Wellington Village (FKA K Park)

STAFF REPORT

Petition Numbers: Rezoning
2025-0003-REZ
Ordinance No. 2026-06

Master Plan
2025-0001-MP
Resolution No. R2026-03

Image D: Landscape Buffers

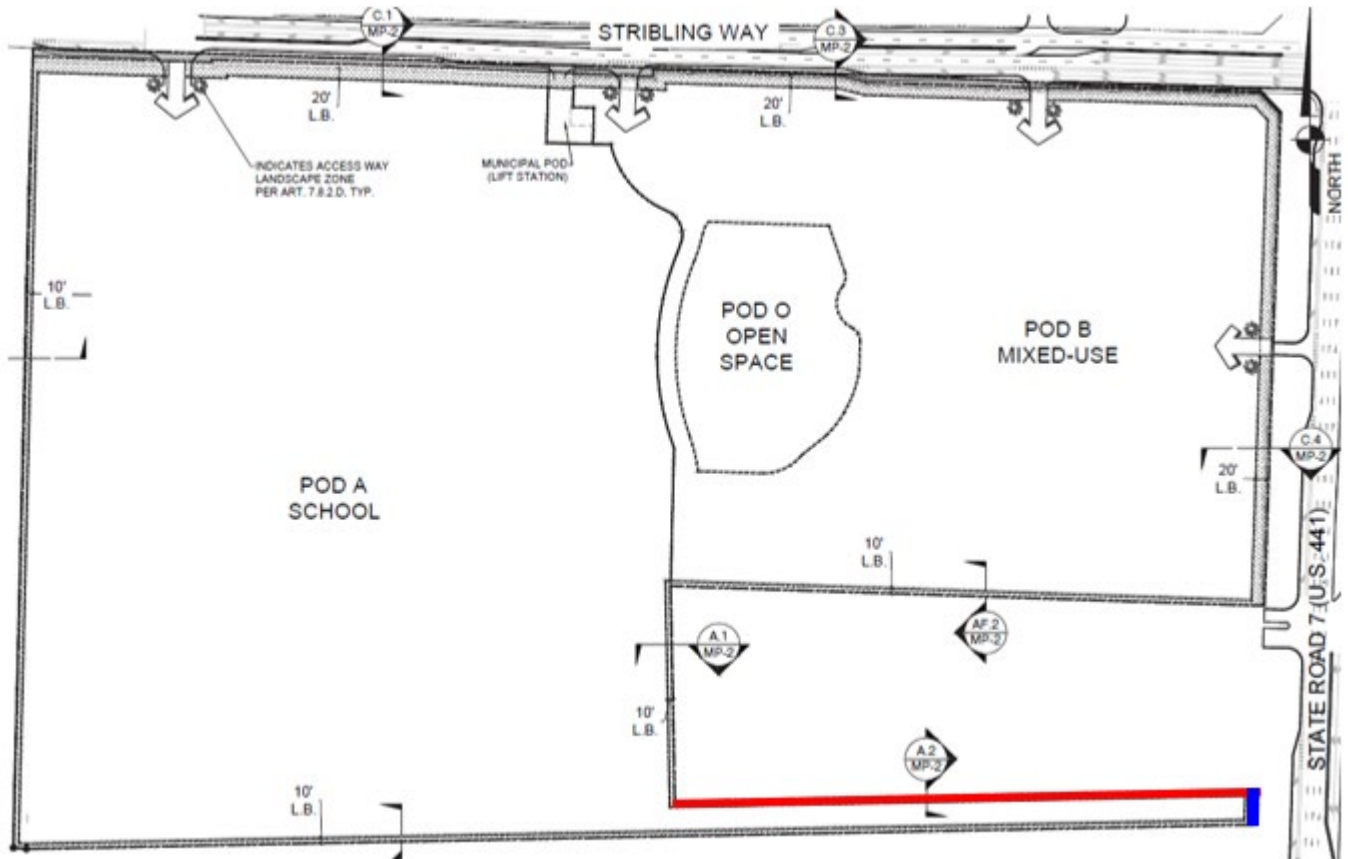
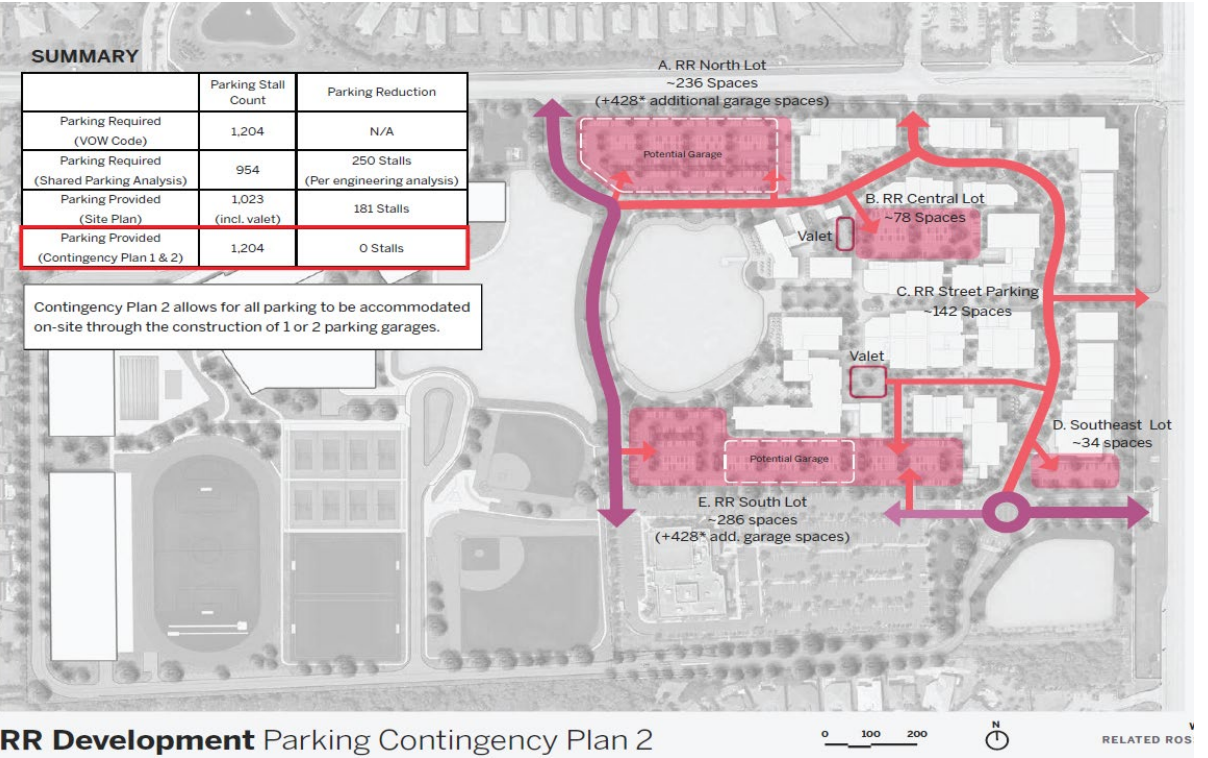
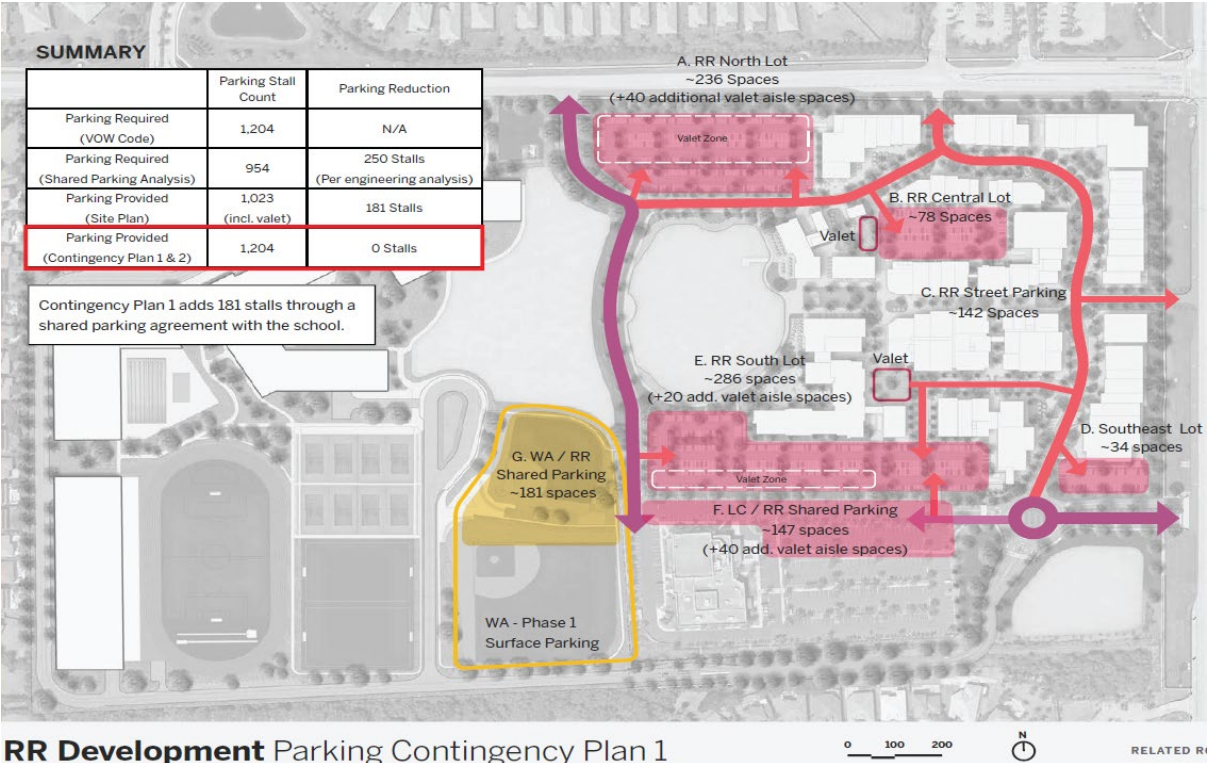
6. **Fence/Wall Location within Landscape Buffers:** Section 7.8.5.C.7 of Wellington's LDR states that if a fence or wall is required within a landscape buffer, the landscaping shall be located between the fence or wall and the adjacent property or right-of-way. The proposed PSM proposes that the fence or wall may be located at the property line where the adjacent property has an existing buffer for the west and south property lines for Pod A. There is no objection to this request.

7. **Outside Activity Area Buffers:** Section 6.2.2.F.5 of Wellington's LDR requires schools that have outside activity areas be buffered a minimum of 50 feet in width from adjacent residential. The athletic facilities proposed in Pod A are situated towards the southern portion of the site. A 10-foot-wide Type A/F landscape buffer, which includes one (1) shade tree per 30 linear feet, a continuous hedge, and a fence or wall, is currently proposed along the entirety of the south property line with plantings both within this perimeter buffer and along the north side of the driveway. Additionally, a 25-foot-wide landscaped buffer exists beyond the southern property line of Pod A on the adjacent Farmington Estates neighborhood. There is no objection to this request as the intent of the outside activity area buffer requirement will be met through the existing landscape on the adjacent Farmington Estates property and the proposed site design.

8. **Type A Buffer (North adjacent to Church parcel):** A modified 10-foot-wide Type A buffer, which includes the elimination of the required shade trees for every 30 linear feet, is requested along the north side of the Pod A access easement south of the Church site (shown as the red line in Image D). The applicant is requesting the deviation due to the existing overhead utility lines along the access strip, which impact the ability to properly plant shade trees at the required height established in the LDR. FPL imposes "Right Tree, Right Place" requirements, which limit the type of species and height that are planted in areas that are beneath the overhead lines. As such, the proposed deviation requested allows compliance with FPL requirements. A continuous hedge and Native ornamental grasses will still be planted. There is also existing buffer material on the church property that further screens the access drive within this area. There is no objection to this request.

9. **Type A/F Buffer (South Property Line):** A landscape buffer deviation is requested to eliminate the required fence within Type A/F buffer for the eastern portion of the southern property line between the proposed control access gates and SR 7 (shown as blue line in Image D). A modified Type A/F buffer is provided along the south side of Pod A, consisting of a proposed masonry wall at a minimum of 6 feet in height located at the property line and terminating at the southern gate access into Pod

A. The eastern portion of the southern property line, where a wall is not proposed, does not contain any building square footage or active uses; it consists solely of a driveway that provides access to the school site from the roundabout located on the Church property and landscape open space consisting of a dry detention swale. Additionally, an existing landscape buffer along the northern property line of Farmington Estates, the residential community to the south, provides further screening for the areas where a wall is not proposed. The applicant is also proposing a masonry wall in lieu of the required fence, providing a higher quality aesthetic and improved site security compared to the fence that is typically required in a Type A/F buffer. There is no objection to this request.

Image E: High-Turnover Zone

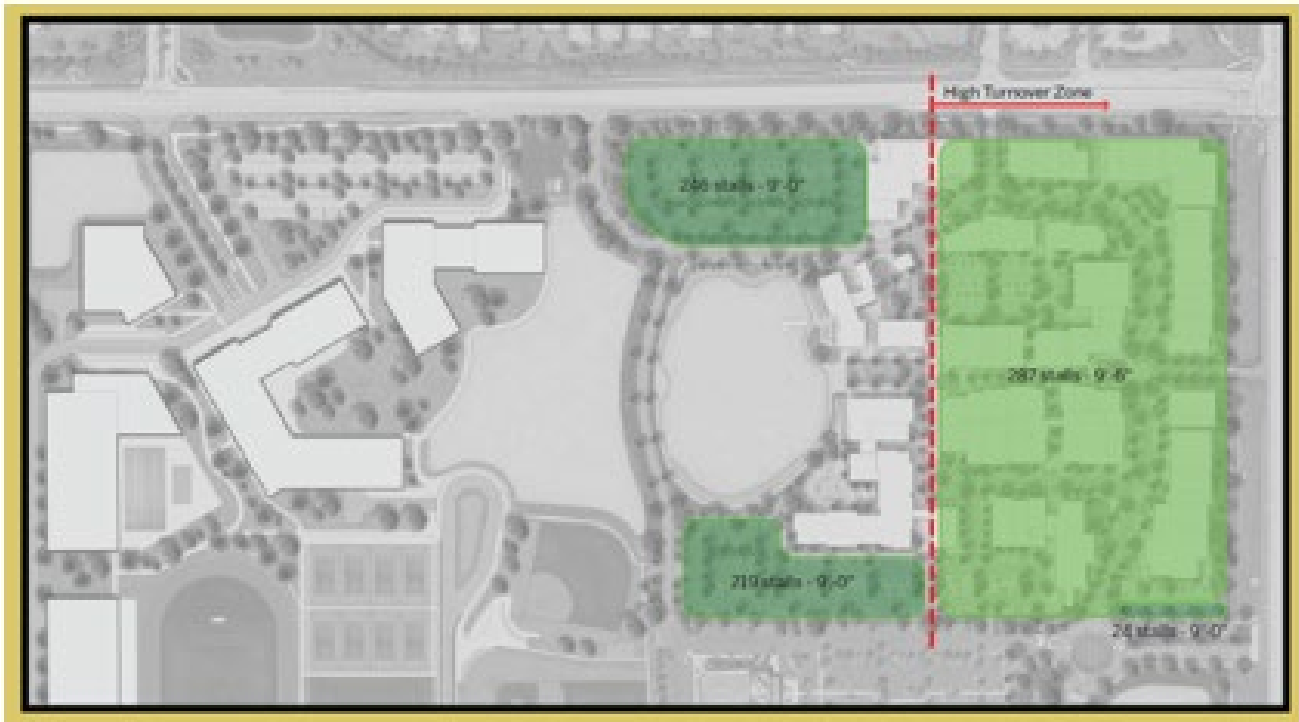
2. **Parking Stall Width:** Required parking stall width is 9.5 feet. The proposed Pod B PSM includes a parking stall width of 9 feet, which is not considered appropriate for high turnover areas. The areas considered in the “high Turn-Over Zone” shown in Image E are anticipated to be the most utilized and desirable parking spaces for Pod B and are located along the Main Street corridor and the central parking lots closest to the storefronts. The parking lots west of Building A1 and south of the Hotel building are located in non “High-Turnover Zones” and are the subject of the deviation request to allow parking spaces 9 feet in width. There are no objections to this request.

Image H: Pod B Landscape Buffer

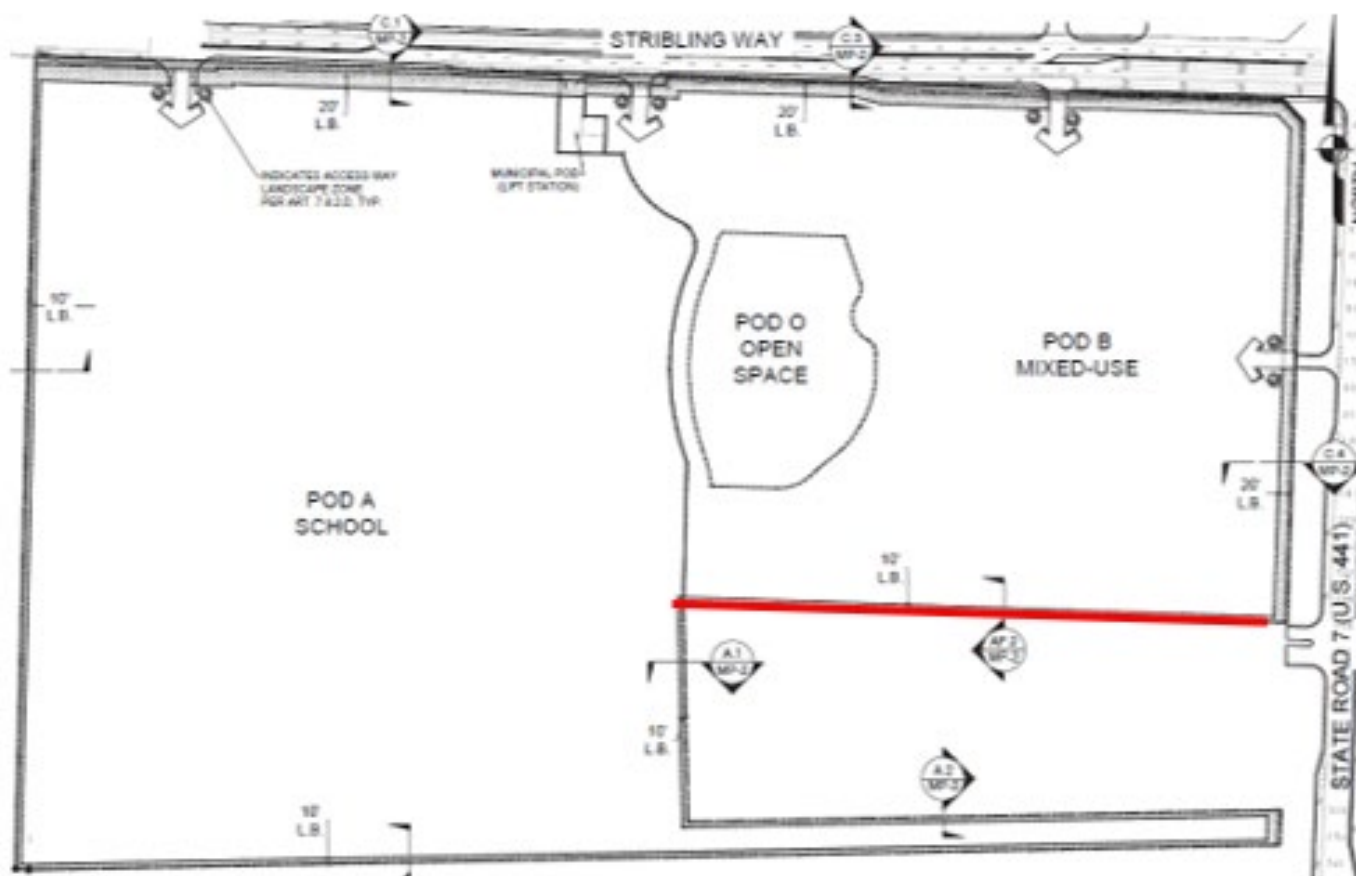
7. **Buffer Type A/F (South):** A landscape buffer deviation is requested to eliminate the required fence within Type A/F buffer for the southern property line adjacent to the Life Church property (shown as red line in Image H) at the request of Life Church. There is no objection to the request.
